WOKINGHAM
BOROUGH COUNCIL

WBC Highways

From:	Ben Amey Development Control		
Service	WBC Highways	App No:	250931
Address:	Finchwood Park, Sheerlands Road, Arborfield, Wokingham, RG40 4QY.		
Proposal:	RM on O/2014/2179 - 161 dwellings parcels Parcel 11 and Parcel 12		
Site Visit Made:	Yes/No

Initial comments were provided on 26th June 2025. Revised plans were submitted and additional comments dated 17th October are provided in **Green**.

Refuse Vehicle Overrun

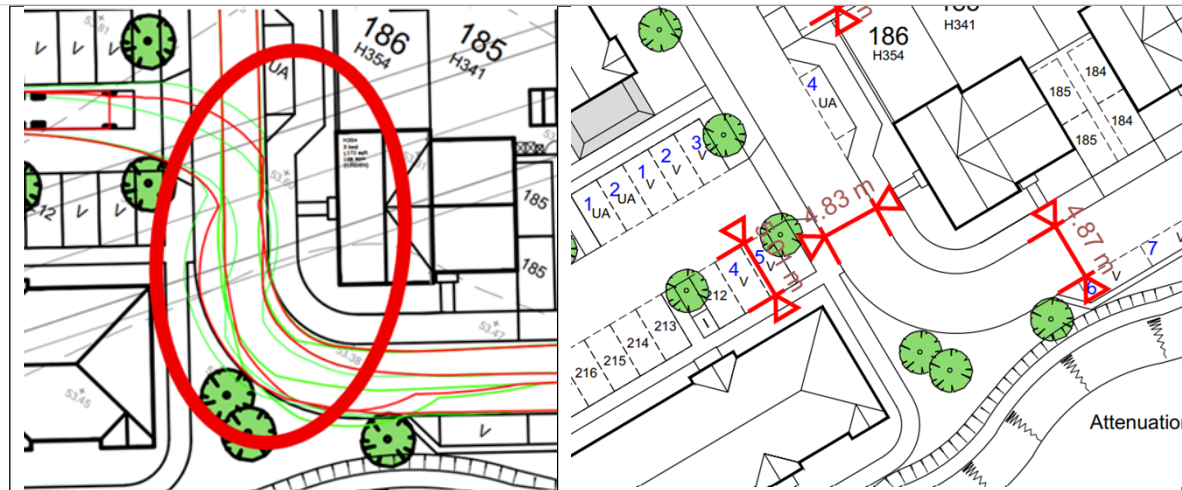
4. The swept paths for a refuse vehicle show that there are 3 areas where a refuse vehicle body and chassis would overrun the footway to the south-west of Plot 186.

5. The swept paths should show that a refuse vehicle and a large can pass each other (as per the preapplication advice provided by the LHA).
6. The LHA require the applicant to adjust the carriageway width, corner radii and provide amended swept paths which demonstrate a refuse vehicle will not overrun the footway and risk pedestrian safety. Measurements taken from the submitted site plan indicate that the carriageway width at this location is only 4.8m wide; rather than the 5.0m proposed and required by WBC.

7. Forward visibility of 25 metres should also be demonstrated around the bend for the 20mph speed limit, as only a 15mph visibility has been shown. The LHA are concerned that without suitable passing space and without suitable forward visibility there could be conflicts between refuse vehicles and cars travelling around the bend. Screenshots of the refuse vehicle overrun and measurements of carriageway width are provided below.

a. The site layout and swept paths have been amended and the refuse vehicle no longer overhangs the footway in these areas.

a. Forward visibility for a 20mph speed limit has now been shown on the drawing submitted by Stuart Michael Associates.

Inadequate Carriageway Width

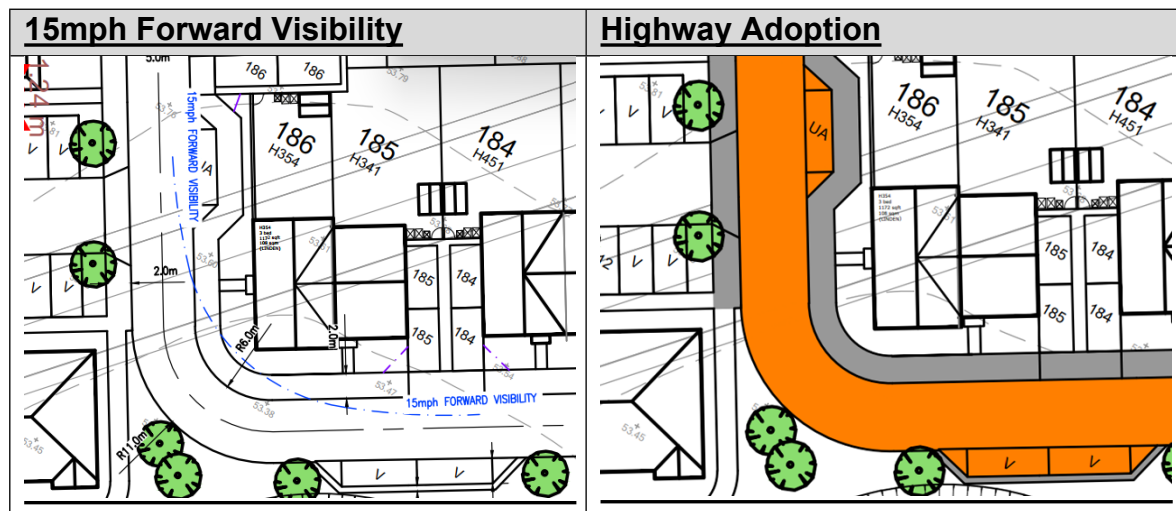
8. Furthermore, the 15mph visibility splay shown passes through land which is not offered for adoption as public verge/highway. Therefore, the 15mph visibility is not only substandard; but cannot be guaranteed given a fence could be erected within the splay. Screenshots highlighting the problem are provided below:

a. The adoption plan has been amended to include land within the visibility splay. This issue is now resolved.

Visitor/Unallocated Parking Space Dimensions

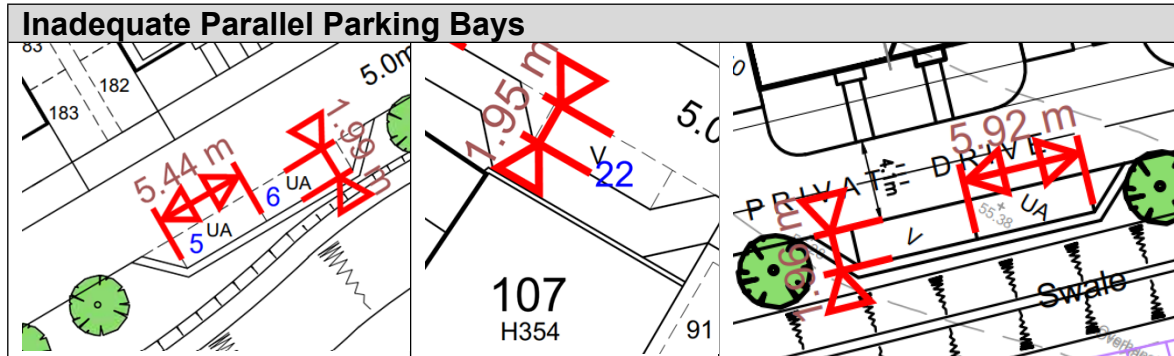
11. The parallel visitor spaces do not meet WBC dimensions and only measure 5.4m – 6.0m long x 1.91m – 2.0m wide. The WBC Parking Standards require 'Where spaces are parallel to the aisle or access road, they should be 6.5m in length and 2.5m in width'.

a. *The spaces appear to have been made larger to meet the WBC Minimum Dimensions.*

Cycle Parking

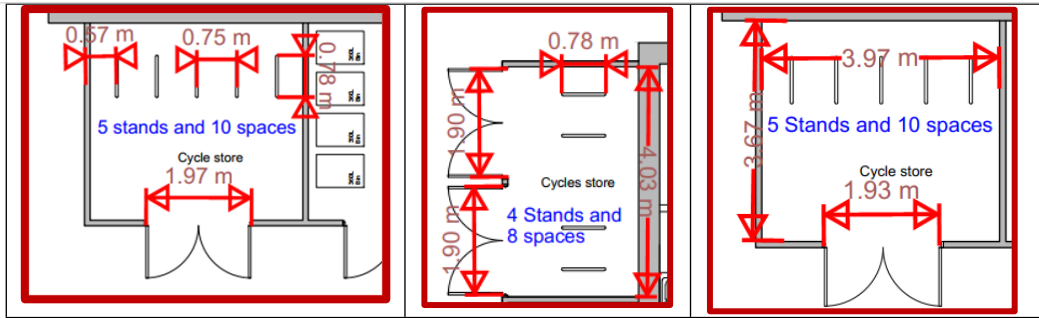
12. The LHA require the applicant to confirm the method of entry to the cycle store (i.e. swipe card or pin pad), provide sliding doors instead of swing doors to improve ease of access and confirm the provision of lighting and CCTV for the store. The WBC Parking Standards refer to Sustrans sheet FF37 which identifies these features as a good cycle store design.
